Gateway One Fire Statement

Renshaw House, Manchester

For: Mia James Construction
Document Ref: 00280-XX-XX-RP-FE-0001
Revision: 02
Date: 13/11/2024

Figure 4 Upper Level Staircore Arrangement

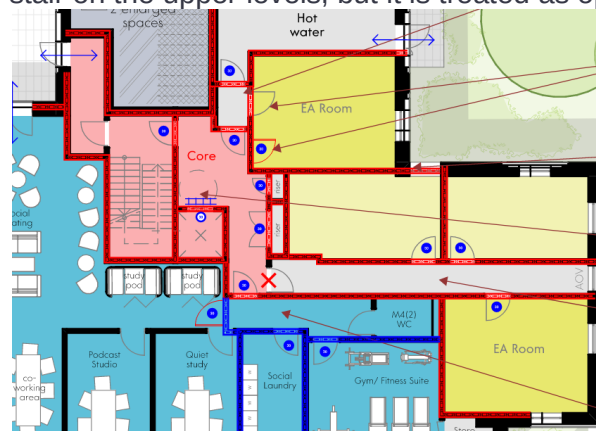
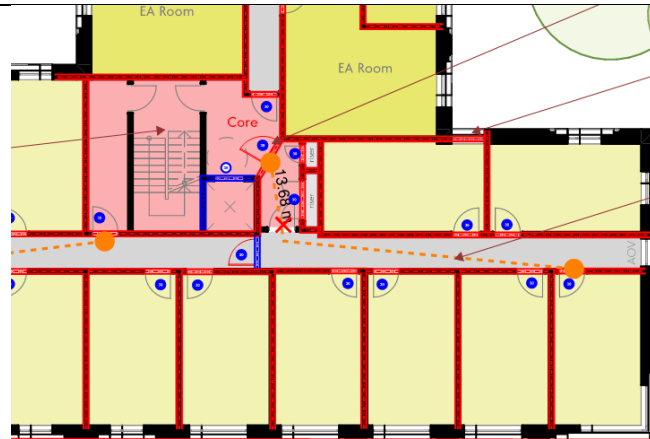
1. All the studio flats are accessed by corridors with single direction travel off the single stair case.

2. The lift shaft is treated as contained within the stair on the upper levels, but it is treated as opening into the corridor at the ground floor level.

It is proposed to treat these corridor as dead-end corridor. As the building is to be provided with sprinkler system, with the provision of AOVs at the end of each of these corridor, the travel distance from the furthest flat entrance door to the stair door can be extended to 15m. At the upper levels, it is considered that the lift shaft is located within the staircase, thus the stair door can be located to be closer to the flat entrance door. With the proposed change, the travel distances with the single direction corridor are all within the limit.

Due to the arrangement of the corridor at the upper level, in order to meet the travel distance limit within the corridor, the lift shaft is considered as being contained within the staircore. However, at the ground level, the lift is outside of the staircore and open into a ventilated corridor. In order to prevent the fire/smoke within the corridor at the ground level compromise the stairs at the upper level, it is proposed to provide fire curtain in front of the lift door at the ground level. The fire curtain should be linked with the smoke detection within the corridor at the ground

floor level. Should a fire or smoke detected at the ground level corridor, the fire curtain should be dropped down to prevent the smoke getting into the lift shaft and also the lift should be called to first floor level instead of the ground floor level.

Proposed Second Floor Plan

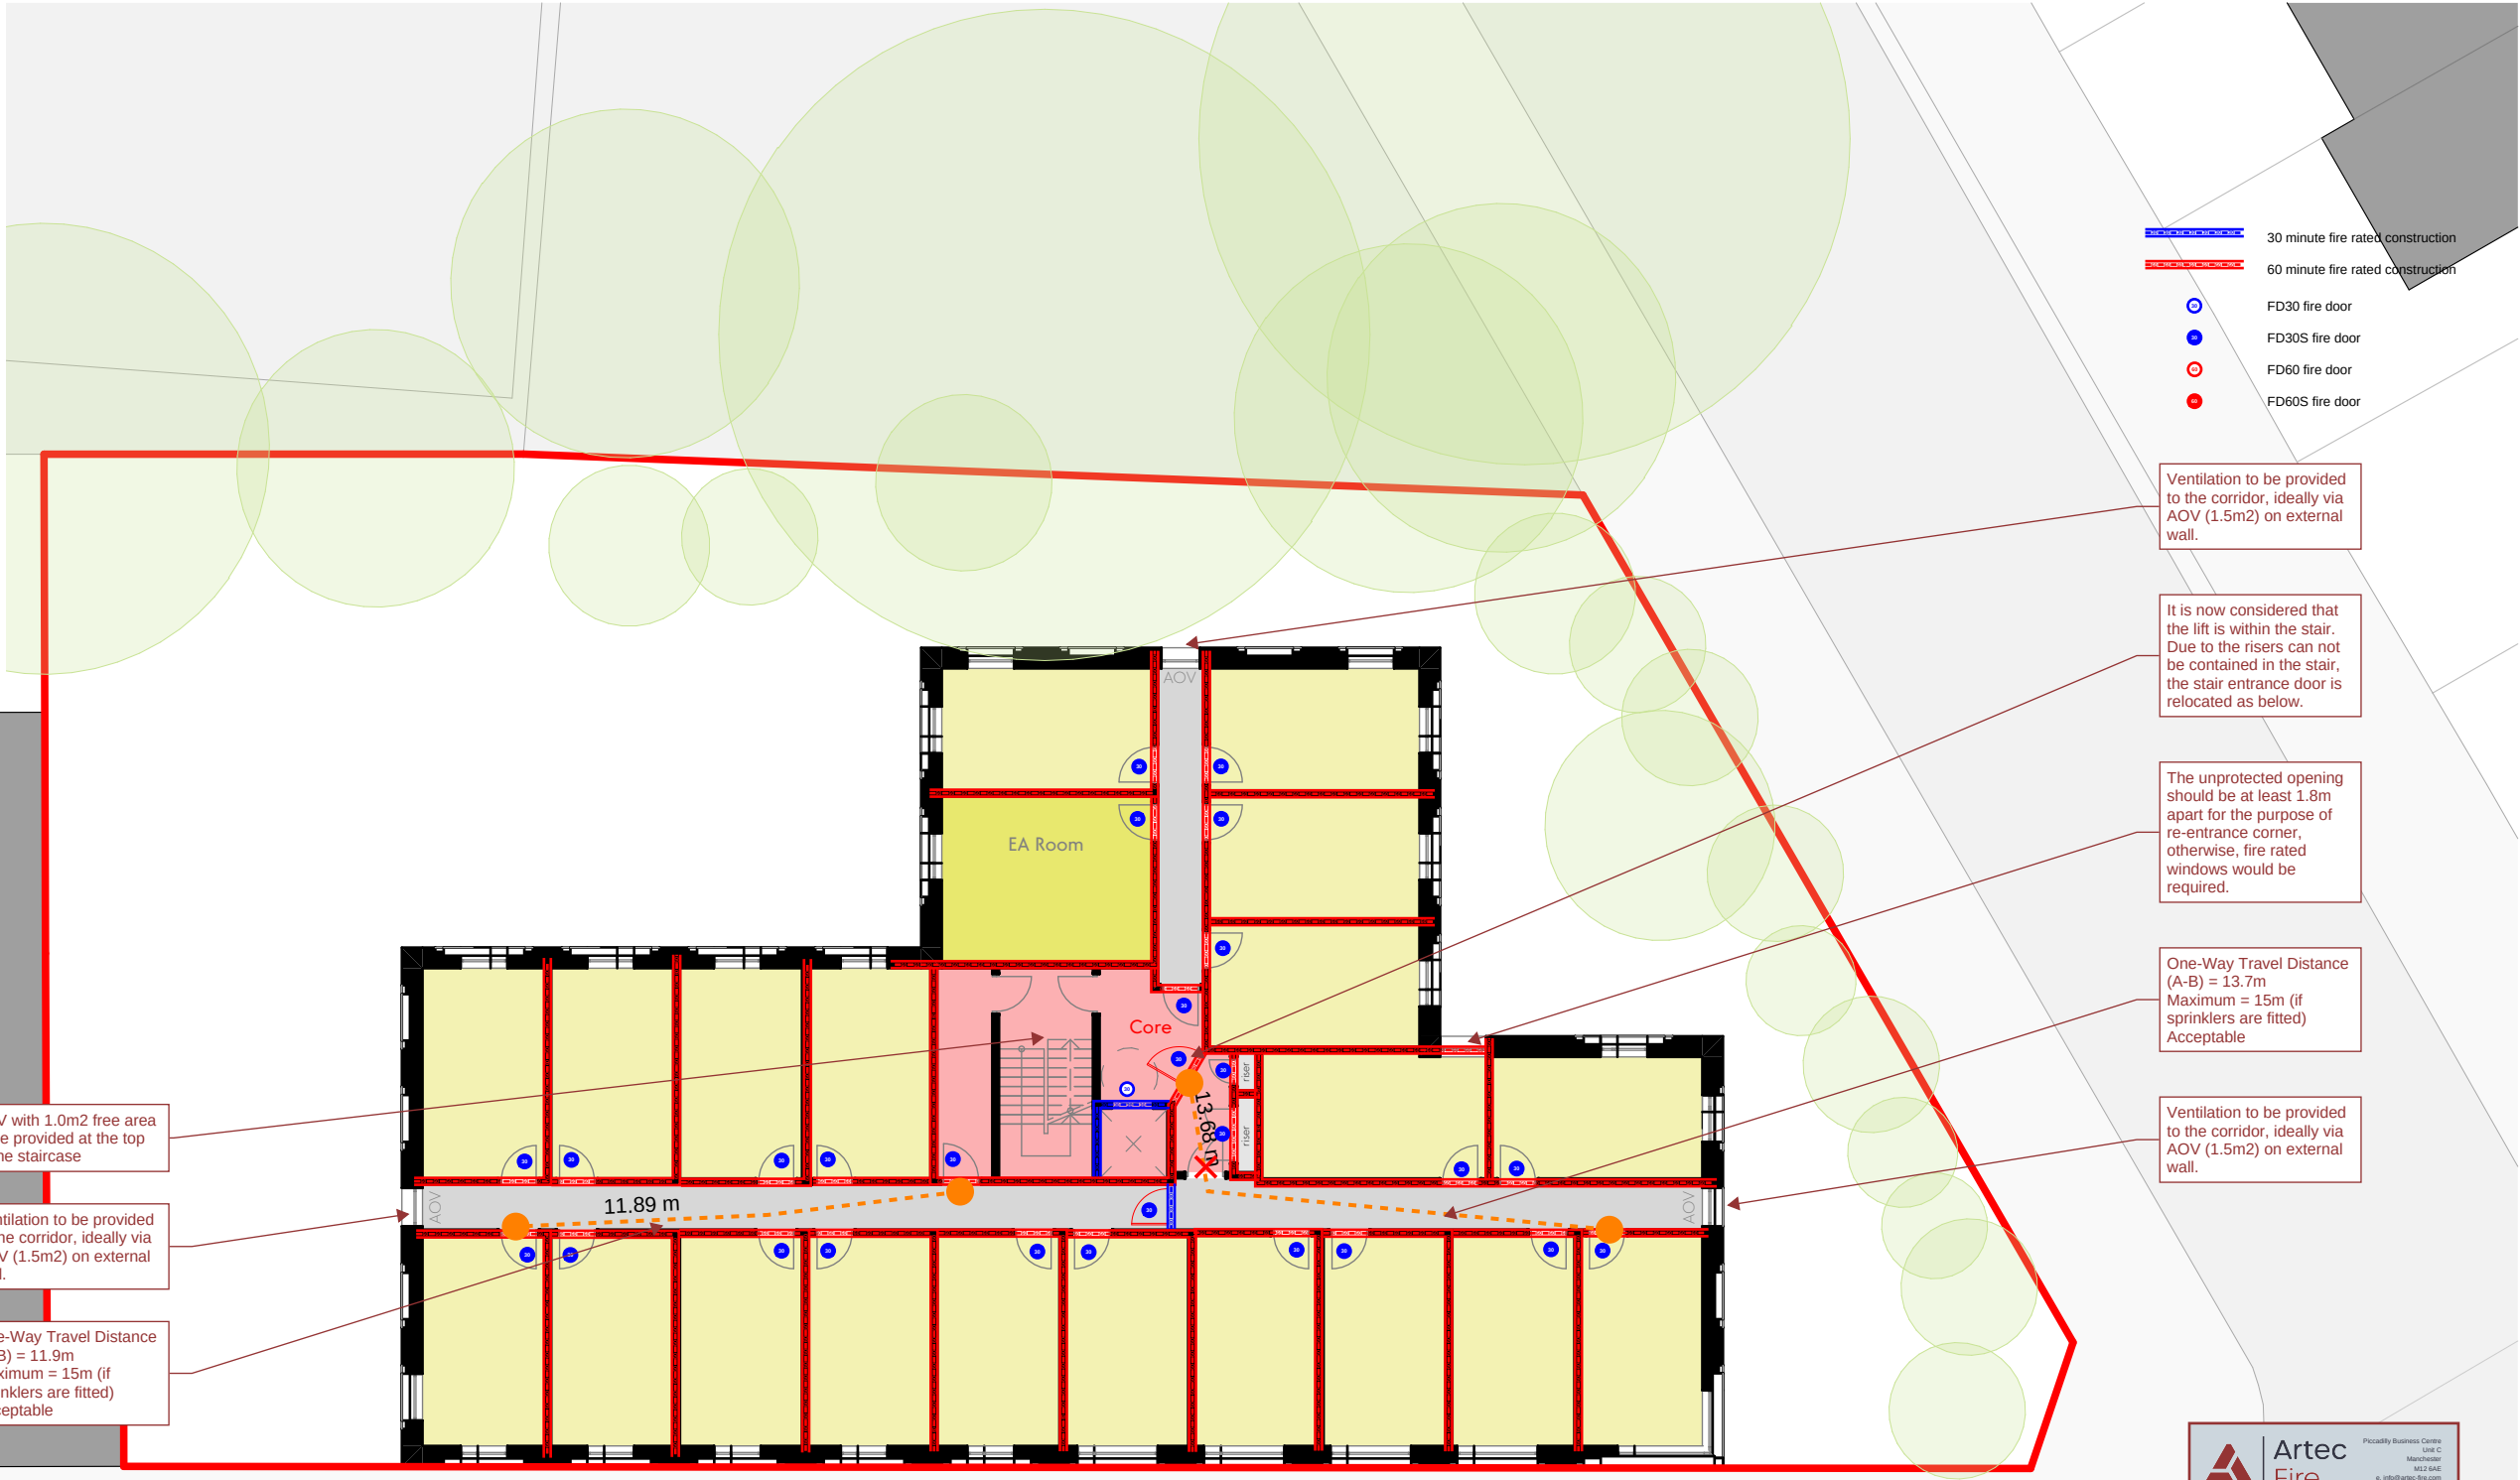
AOV with 1.0m2 free area to be provided at the top of the staircase

Ventilation to be provided to the corridor, ideally via AOV (1.5m2) on external wall.

One-Way Travel Distance (A-B) = 11.9m
Maximum = 15m (if sprinklers are fitted)
Acceptable

Ventilation to be provided to the corridor, ideally via AOV (1.5m2) on external wall.

It is now considered that the lift is within the stair. Due to the risers can not be contained in the stair, the stair entrance door is relocated as below.

The unprotected opening should be at least 1.8m apart for the purpose of re-entrance corner, otherwise, fire rated windows would be required.

One-Way Travel Distance (A-B) = 13.7m
Maximum = 15m (if sprinklers are fitted)
Acceptable

Ventilation to be provided to the corridor, ideally via AOV (1.5m2) on external wall.

Proposed Third Floor Plan

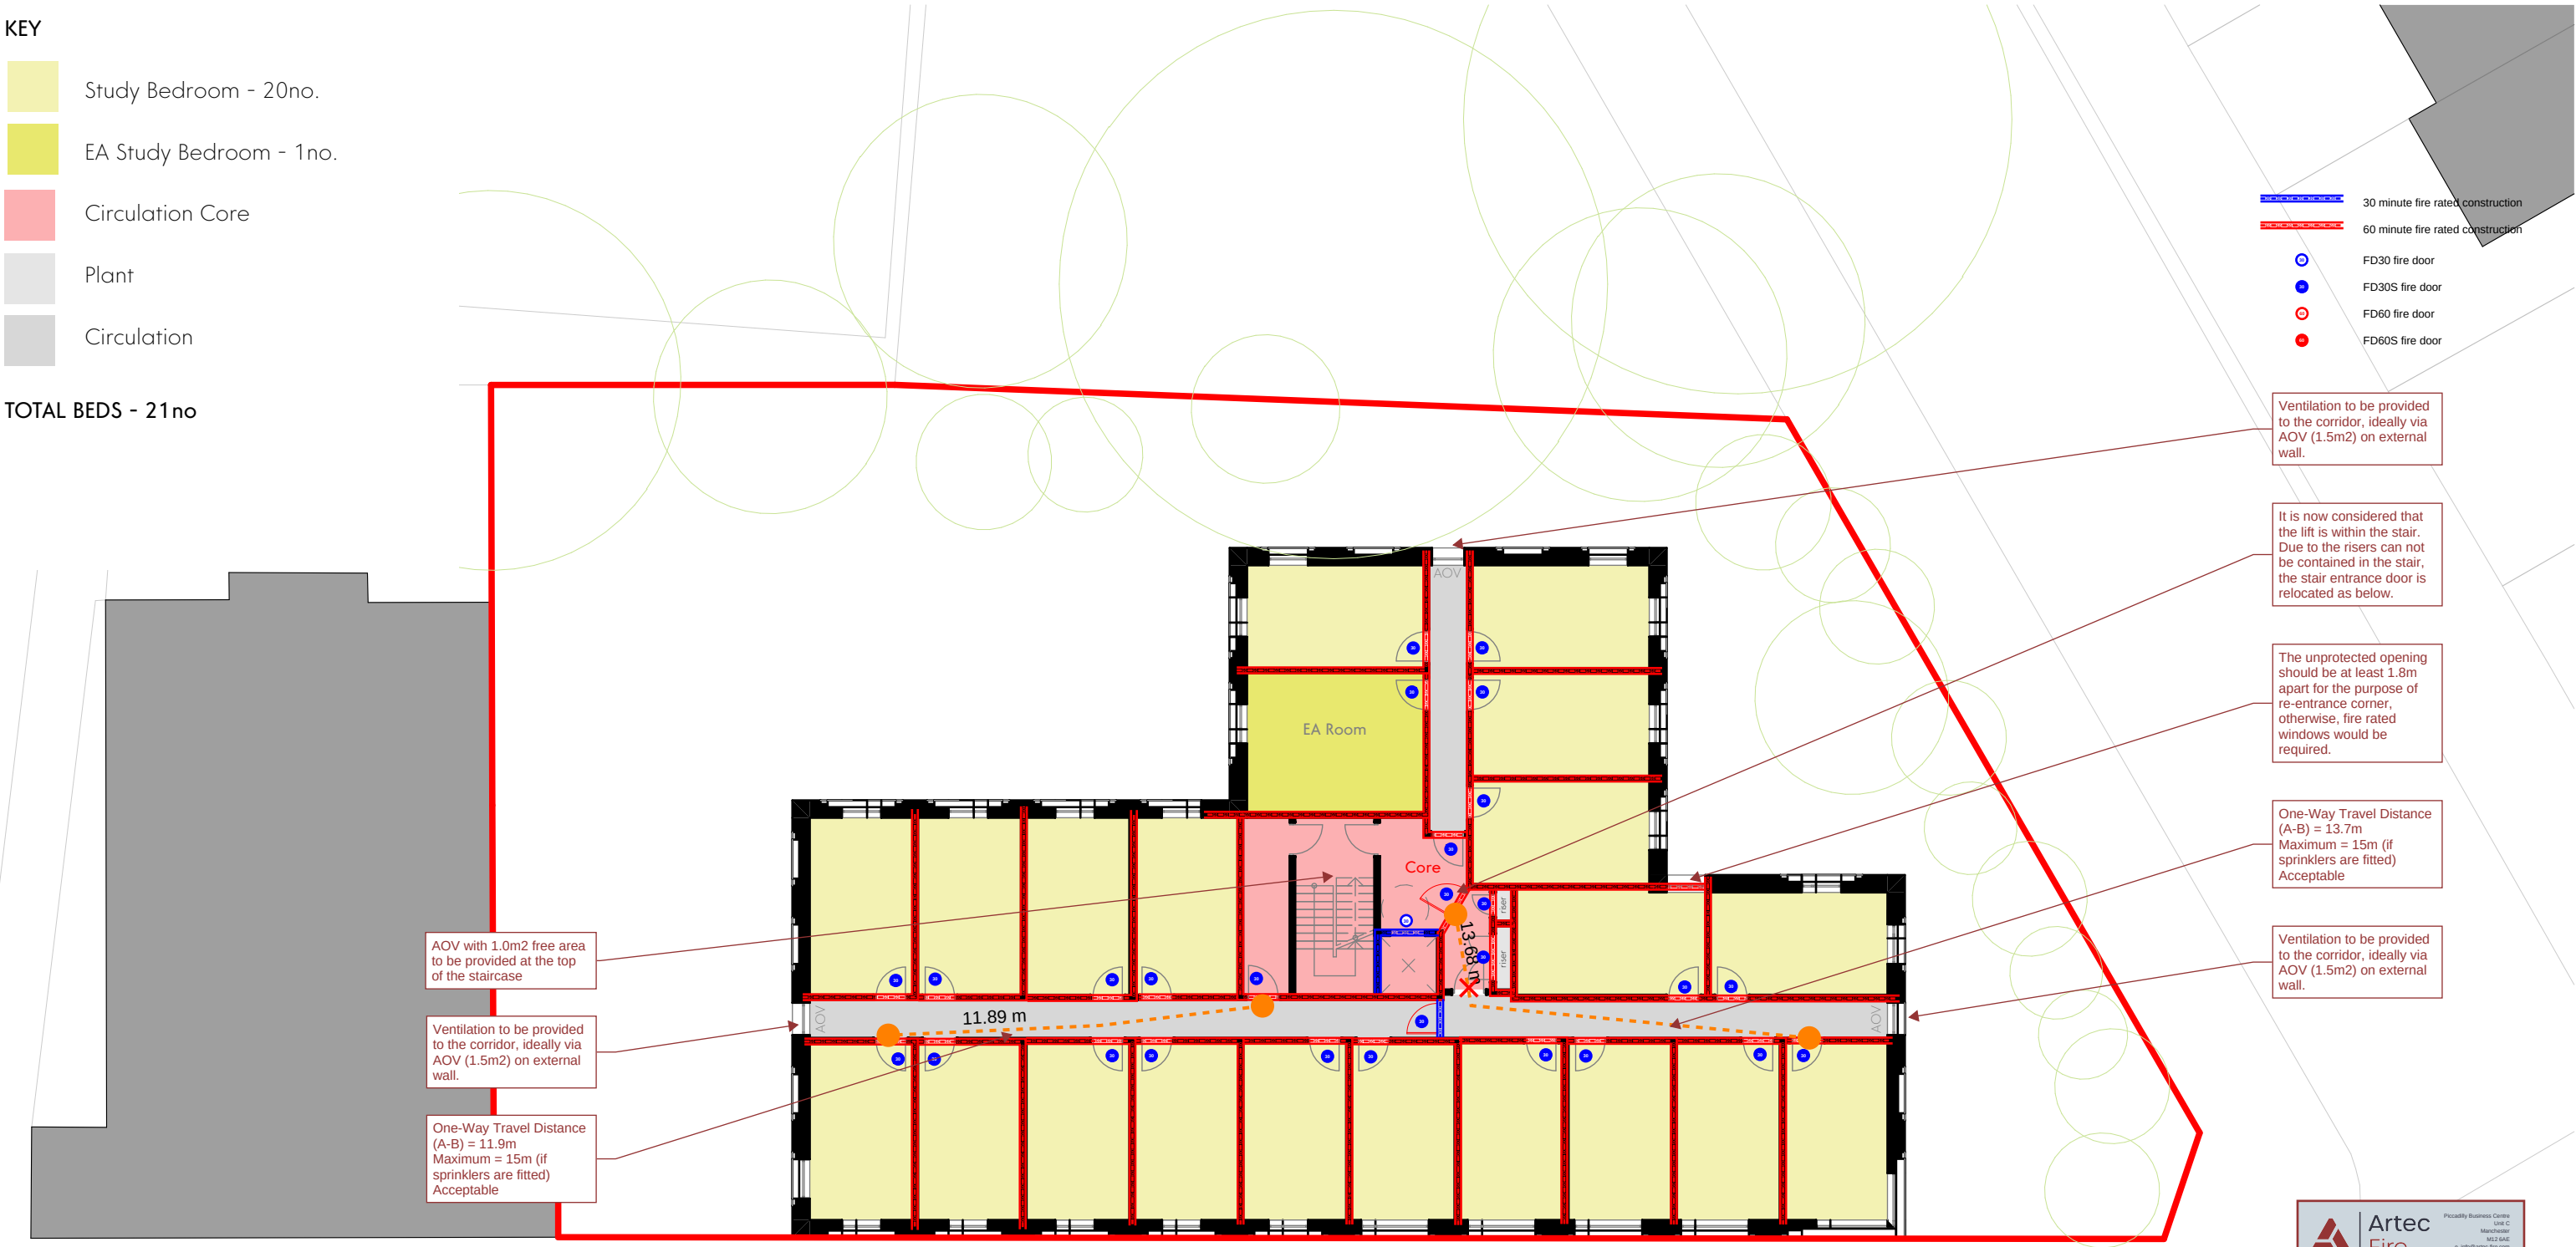
Ventilation to be provided to the corridor, ideally via AOV (1.5m2) on external wall.

It is now considered that the lift is within the stair. Due to the risers can not be contained in the stair, the stair entrance door is relocated as below.

Ventilation to be provided to the corridor, ideally via AOV (1.5m2) on external wall.

AOV with 1.0m2 free area to be provided at the top of the staircase

Ventilation to be provided to the corridor, ideally via AOV (1.5m2) on external wall.

One-Way Travel Distance (A-B) = 10.2m
Maximum = 15m (if sprinklers are fitted)
Acceptable
